## **CITY OF ATASCADERO DESIGN REVIEW COMMITTEE AGENDA**

**DEVELOPMENT PROJECT REVIEW****2. DESIGN REVIEW OF 7200 NAVAJOA AVE.**

#### **MULTI-FAMILY RESIDENTIAL DESIGN REVIEW, 7200 NAVAJOA**

**DEV 18-0142**  
**13940 Morro Rd, Grading on Slopes >20%**

**Proposed Elevations**

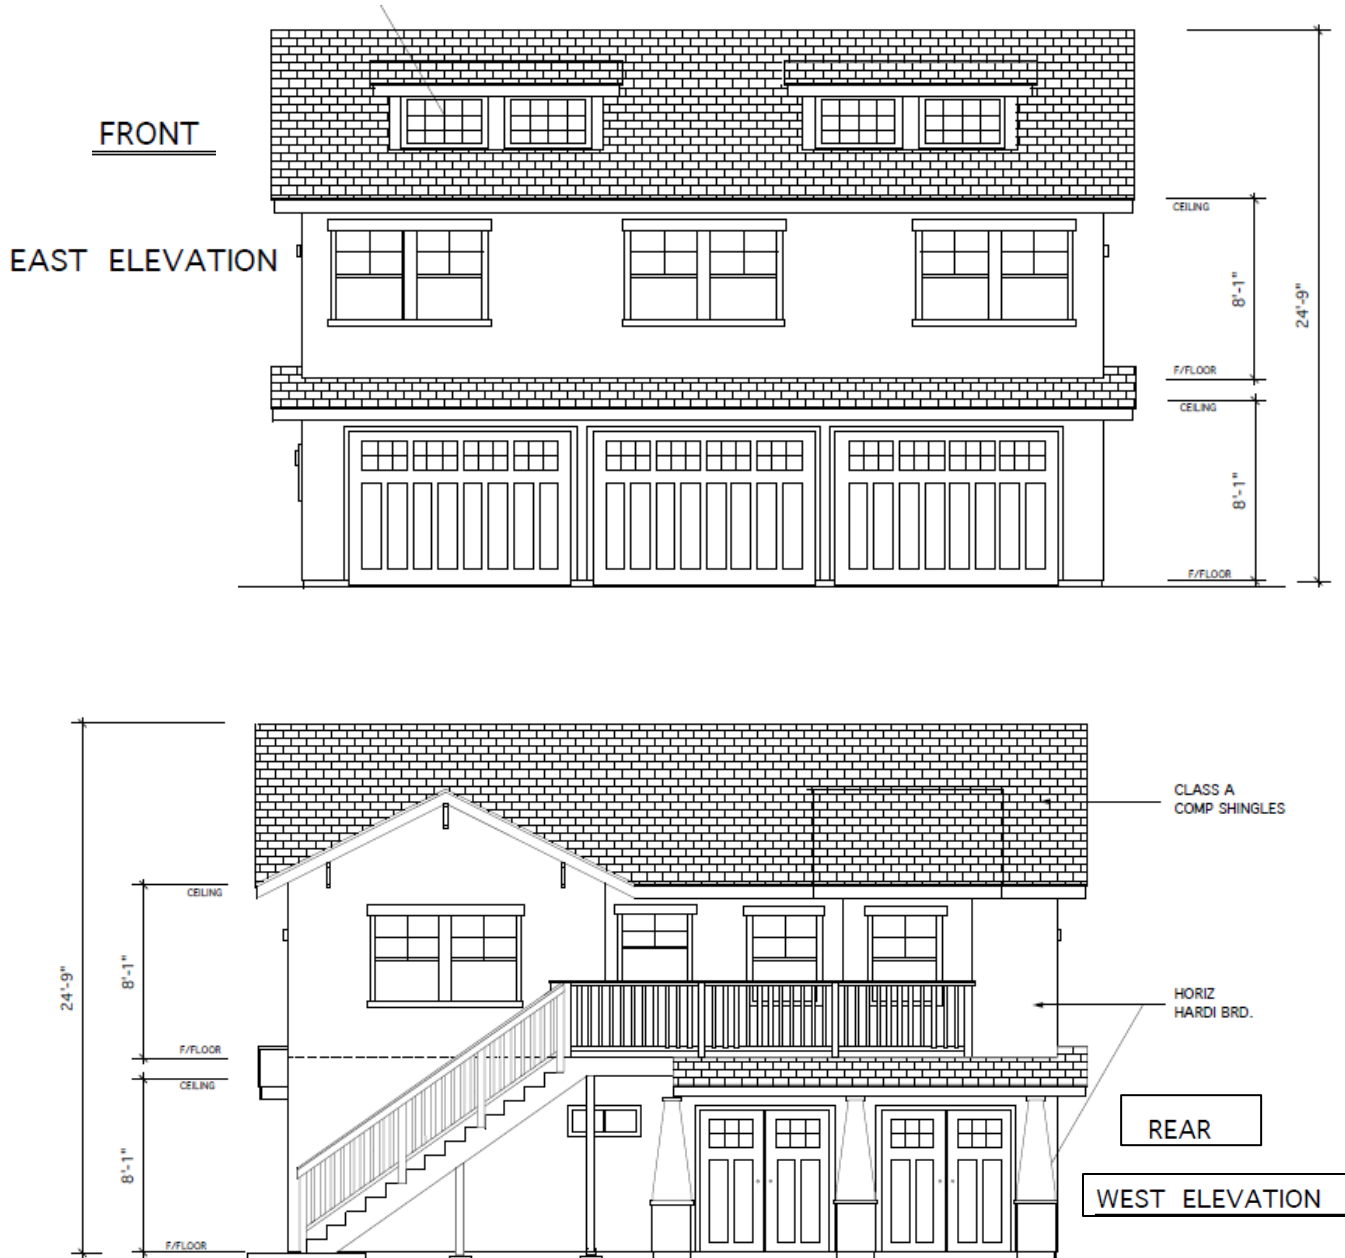
The proposed garage and multi-family units incorporate some of the details of the existing Colony home, including two street facing dormer windows, groupings of hung windows, and decorative brackets. The entrances to the two new units are proposed at the back of the building, next to the rear parking area. Typically, the City encourages front porches and entryways to face the street to enhance neighborhood character. However, the design for this lot is proposed with rear access to the upstairs units in order to maintain privacy for the existing Colony home. A shared staircase is proposed at the back of the building next to the new side driveway to provide access to the upstairs units.

The elevation drawing notes hardiboard siding for the new structures. City staff recommends that this be used on the all sides of the exterior to match the existing Colony home. A color and material board has not yet been provided. City staff recommends a color scheme that will complement the existing Colony home, such as a deep earth toned base color and white trim.

The new garage and multifamily residential structure is proposed at 25 feet in height, which will be at least a few feet taller than the Colony home. The garage is setback approximately 35 feet from the edge of the right-way, at approximately the same setback as the Colony home.

**Site Plan**

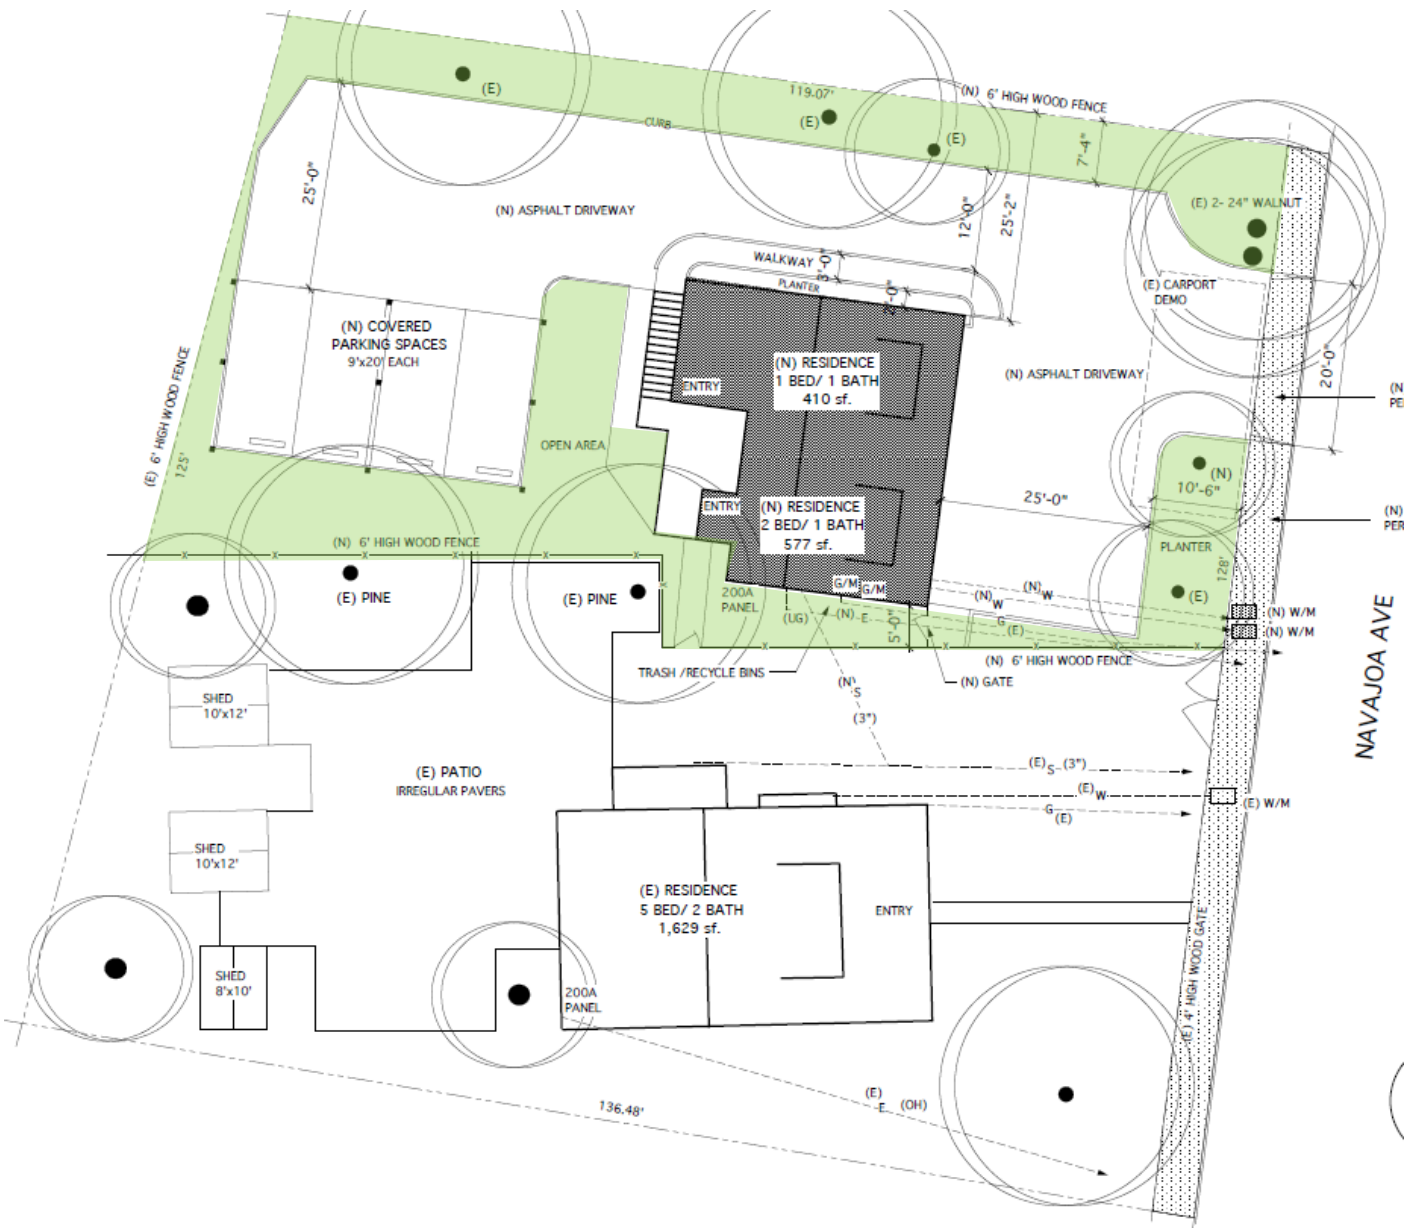
One new driveway approach is proposed on the north side of the parcel to provide driveway access to the back of the lot and the new garage. A 10 foot wide landscape planter would be installed between the garage and the public frontage on Navajoa to minimize the appearance of the new asphalt driveway and provide some screening in front of the garage. A landscaped setback is provided along the north side property line consistent with AMC requirements.

The new 3-car garage will be for the exclusive use of the property owner, and it will provide designated and covered parking for the Colony home. The two new upstairs units are provided parking at the back of the lot. Four (4) paved spaces are provided, and at least two (2) spaces will be covered by a new carport structure, consistent with Municipal Code requirements.

## LANDSCAPE PLAN

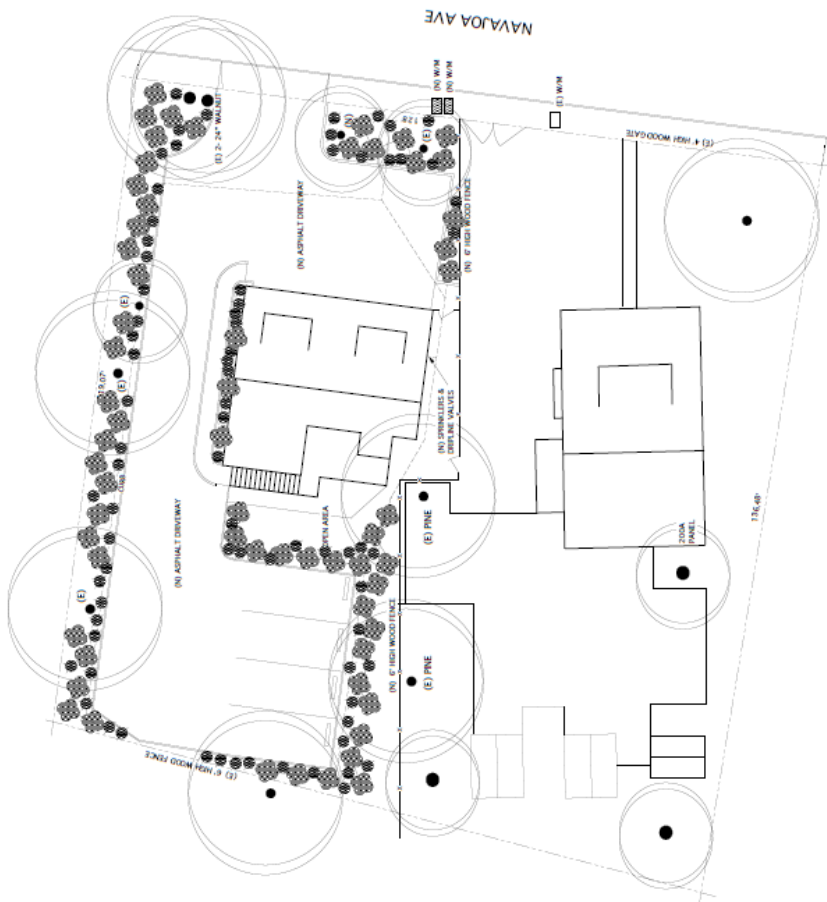
Landscape areas are being proposed on the north half of the lot in conjunction with the new construction. As a multi-family parcel, the whole site will need to be brought into conformance with landscape standards of the code in conjunction with the site development. This would include street trees along the whole length of the frontage, and drought tolerant landscape added to the front yard of the existing Colony home. As identified in AMC section 9-4.125, 25% of the lot must be landscaped in multi-family zones. The plans note that 2270 sq. ft. of landscape is proposed, which is approximately 28% of the area of construction. Areas of landscape should be discussed by DRC to ensure a complete multi-family development.

- Color scheme shall be compatible with existing Colony home, subject to staff approval.
- With building permit, provide landscape and irrigation plan with list of plant species to be used. Shall include London Plane street trees every 30' along frontage, and drought tolerant plants. Density of plantings shall be appropriate to fill planter beds.
- Identify trash storage location for both new units and the existing Colony home. Trash to be located in designated, screened enclosure area.
- Site lighting shall be installed in back parking area and walkways to provide adequate security lighting.
- Fencing to comply with height limitations within front setback.
- Only 2 parking spaces are required to be covered by carport. Carport shall maintain a 10' setback to the rear property line. A minimum of 4 paved parking spaces shall be provided for the two (2) new units.

## PROPOSED PROJECT SITE PLAN

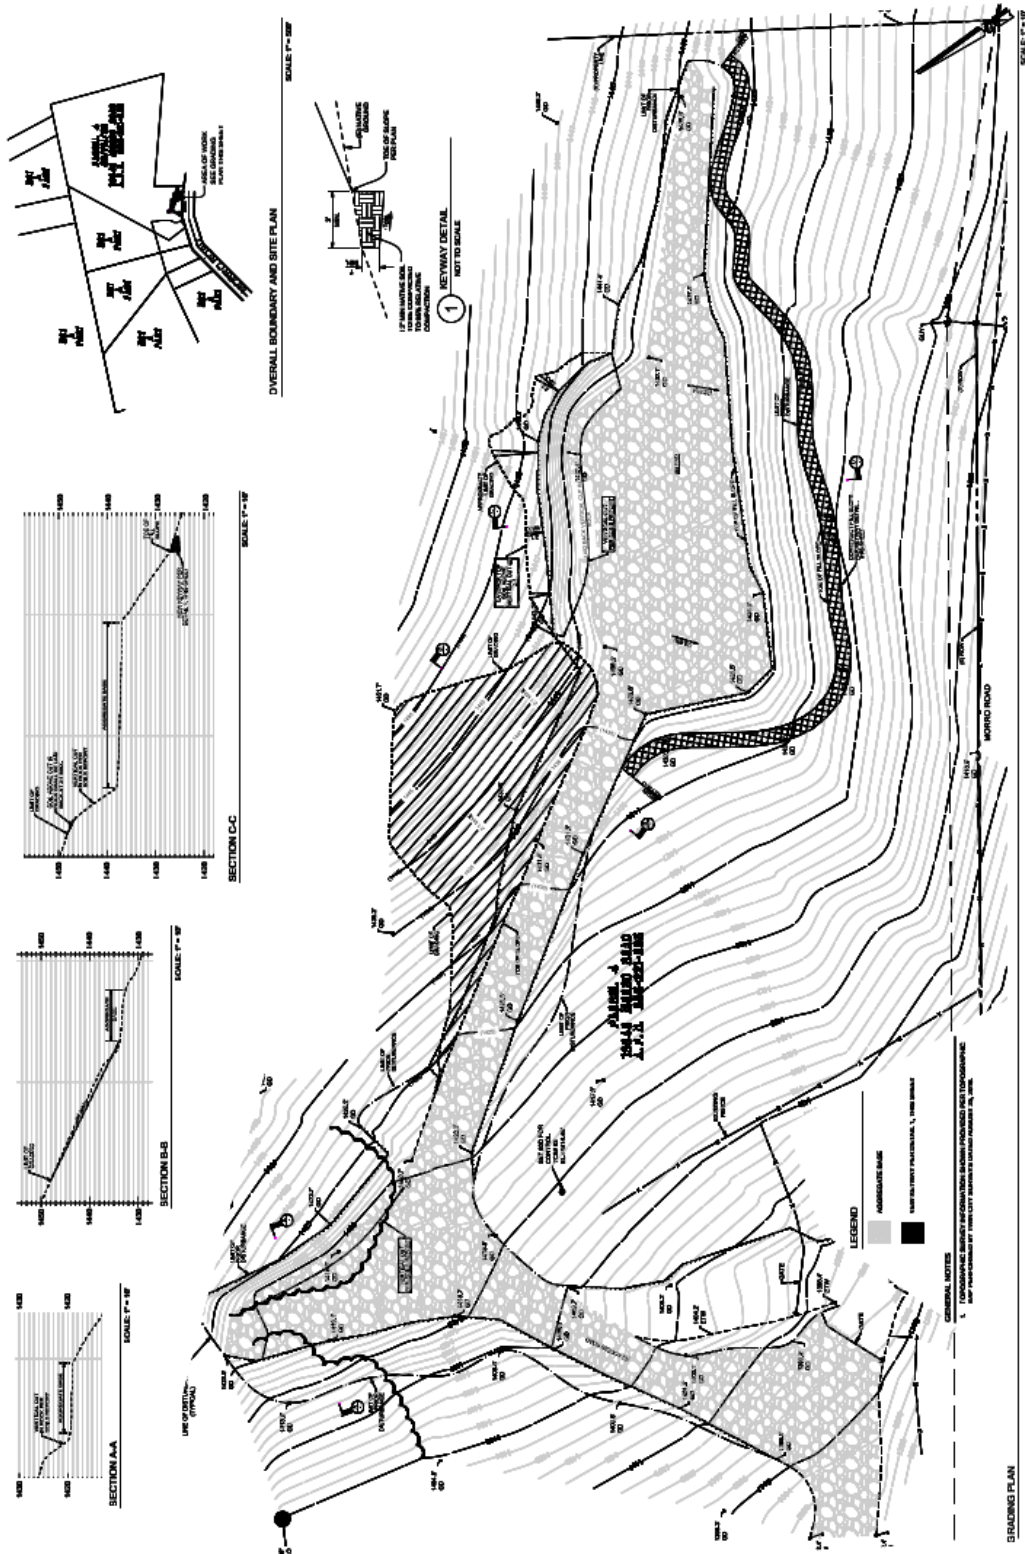
Grading Standards (AMC 9-4.138-145)	<input type="checkbox"/> Yes <input checked="" type="checkbox"/> No	Pad grading proposed on slopes over 30% with no clear relation to development or necessary for use and enjoyment of the residential property.
Water Efficient Landscaping(AMC Title 8, Chapter 10 )	<input type="checkbox"/> Yes <input type="checkbox"/> No	If grading is approved, all landscaping will be required to meet these standards.
<b>ADVISORY BODIES / OUTSIDE AGENCIES THAT REQUIRE REVIEW OF PROPOSED PROJECT:</b>		
<input type="checkbox"/> Native American Tribes <input type="checkbox"/> Atascadero Mutual Water Company (AMWC) <input type="checkbox"/> Caltrans District 5 <input type="checkbox"/> Regional Water Quality Control Board (RWQCB) <input type="checkbox"/> Dept. of Fish & Wildlife (DFW)	<input type="checkbox"/> SLO Air Pollution Control (APCD) <input type="checkbox"/> SLO County  <input type="checkbox"/> _____ <input type="checkbox"/> _____ <input type="checkbox"/> _____

The applicant is proposing the graded area for material and equipment/vehicle storage/parking. The graded area is connected to the driveway to the main house. In addition, a gate is also existing that would allow access off of Morro Rd, although Caltrans has not, to the City's knowledge, permitted regular access in this location. The graded pad is approximately 3,300 square feet with additional grading to blend the cut and fill portions back into the natural slope.

Attachment 3: Neighbor Comment Letter, Ted Bench

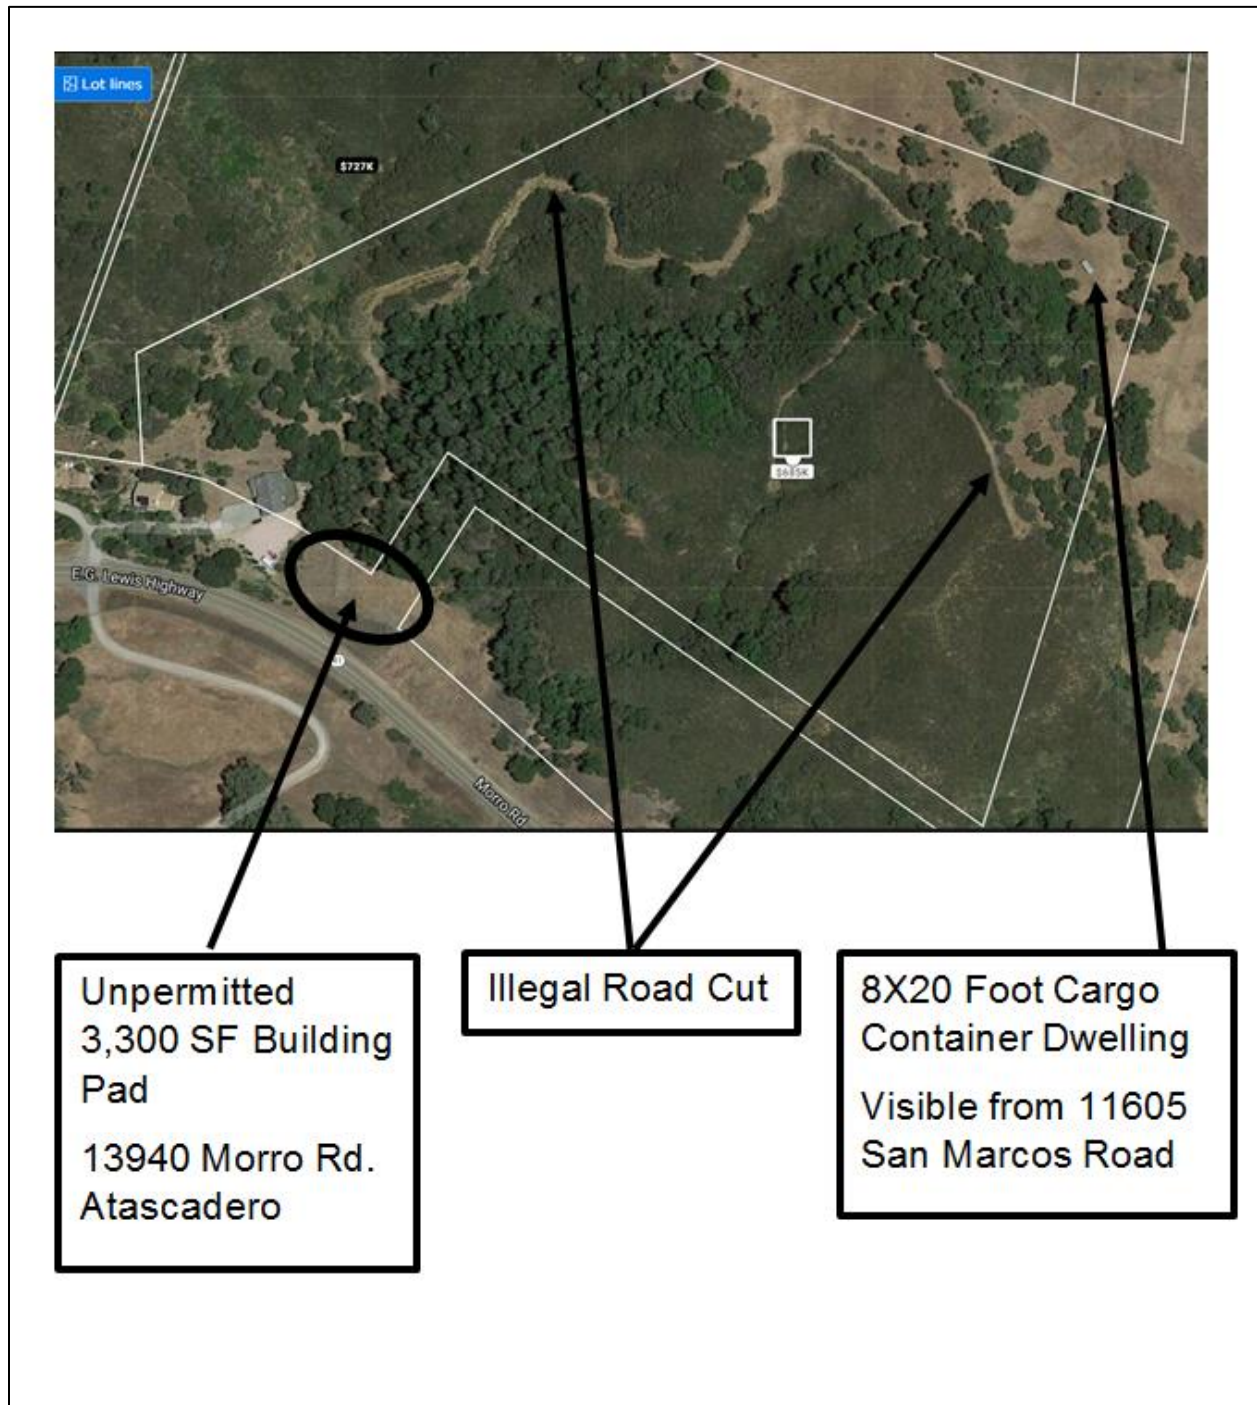
Please consider the additional illegal grading on-site on the hillside above the unpermitted pad. A dirt road was graded to the ridge top and an 8X20 foot cargo container dwelling unit was installed at the top. The Calif. Dept. of Fish & Game may need to be notified to check the extent of eroded fill in the canyon below the road cut.

- Remove the 8X20 foot cargo container dwelling unit.
- Return the road cuts to a natural / stable condition as much as practical, to the satisfaction of the Calif. Dept. of Fish & Game.
